Subject: Transmittal of Revision 1, Service Bulletin Number V2500-NAC-78-0187

**Number:** V2500-NAC-78-0187, Revision No. 1

**SUBJECT:** COMMON NOZZLE ASSEMBLY (CNA) PEN NIB FAIRING AFT SEGMENTS  
REPLACEMENT

CNA Bifurcation Fairing Aft Segment Replacement  
Figure 1

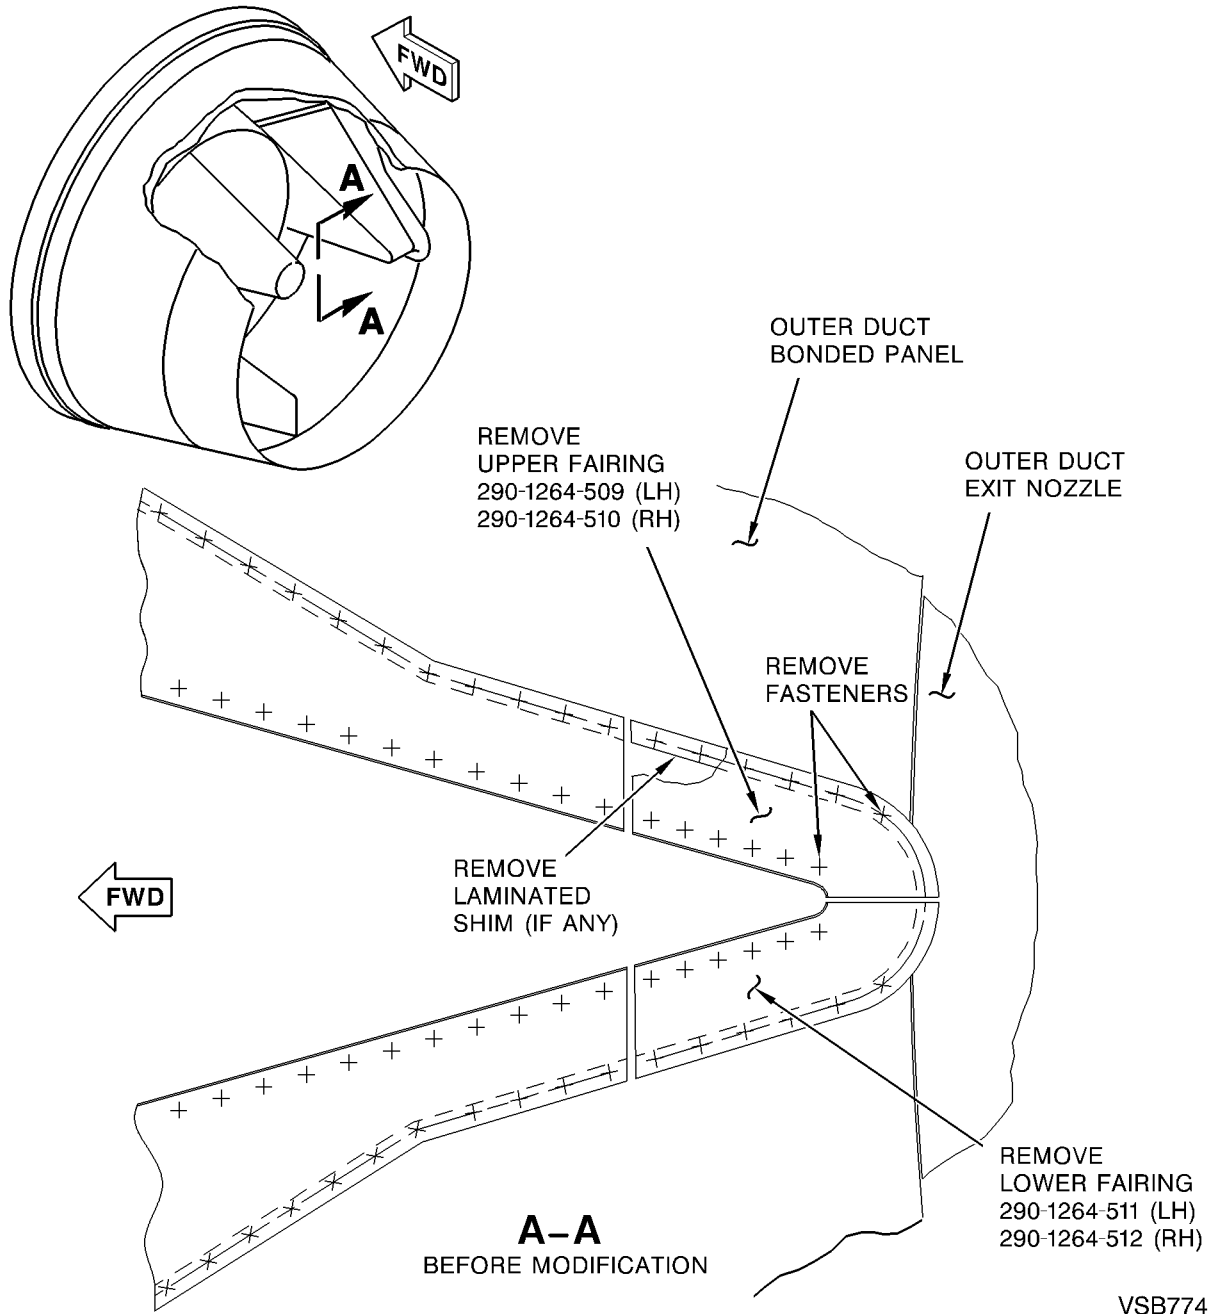
A. Remove the CNA pen nib fairing aft segments. Refer to Figure 1.

(1) Remove the fasteners, fairing segments, and any shim and liquid shim from the CNA.

CNA Bifurcation Fairing Aft Segment Replacement  
Figure 2

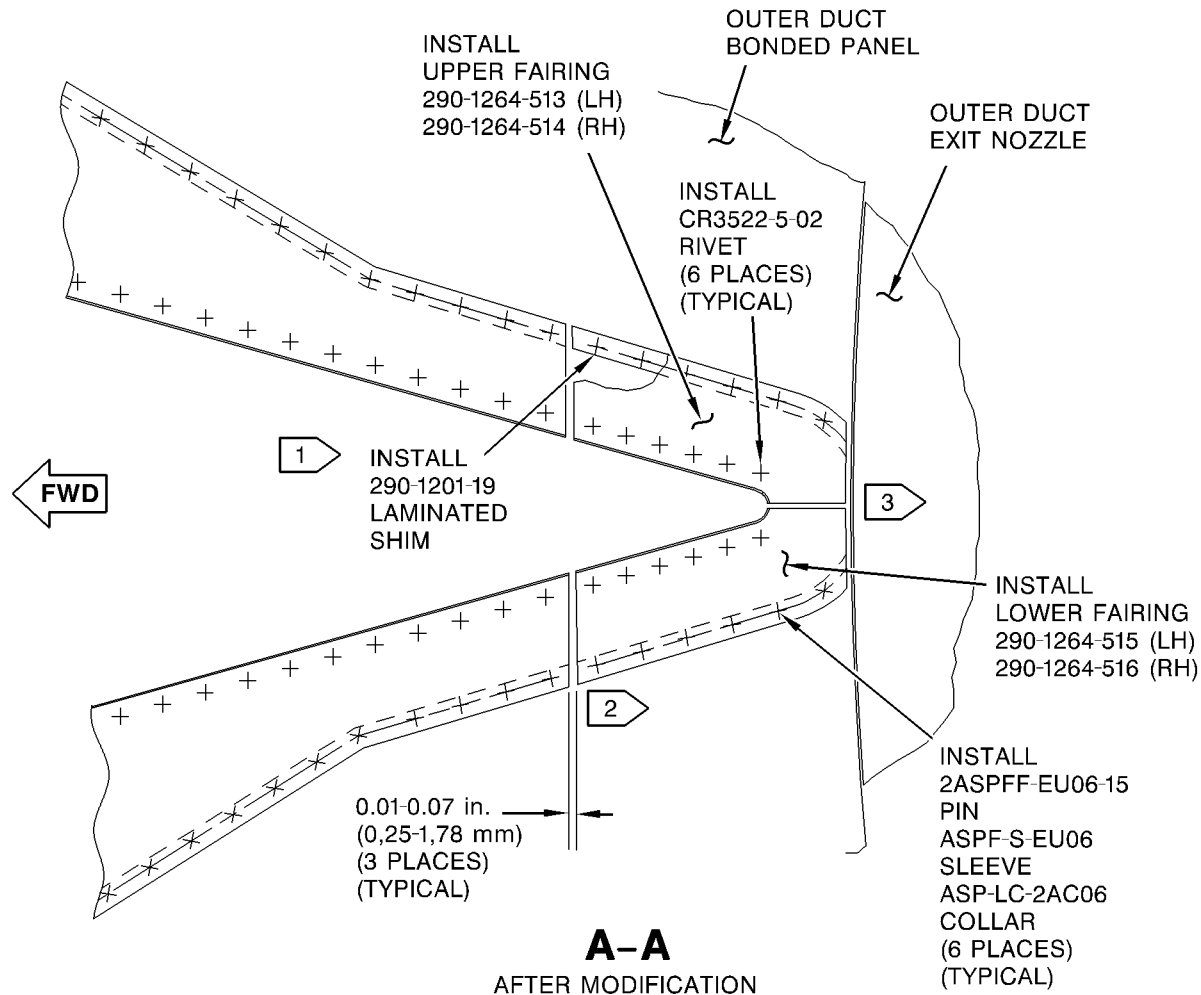
(1) To revise Figure 2.

B. Install the new fairing segments. Refer to Figure 2.

(1) Put the new segments into position on the CNA. Remove material from the segments as necessary to get the space between the segments specified in Figure 2.

NOTE: The fairings must be level with each other within the limits specified in Figure 2. Use liquid shim for shimming requirements of less than 0.030 inch (0,76 mm).

- NOTES:
- 1 INSTALL THE SHIM BETWEEN THE FAIRINGS AND THE BONDED PANEL AS NECESSARY. FOR SPACE LESS THAN 0.030 in. (0,76 mm), USE LIQUID SHIM.
  - 2 MAXIMUM ALLOWABLE STEP BETWEEN THE FAIRINGS:  
0.025 in. (0,64 mm) INTO THE WIND.  
0.040 in. (1,02 mm) OUT OF THE WIND.
  - 3 MAXIMUM ALLOWABLE STEP BETWEEN THE FAIRINGS:  
0.040 in. (1,02 mm).
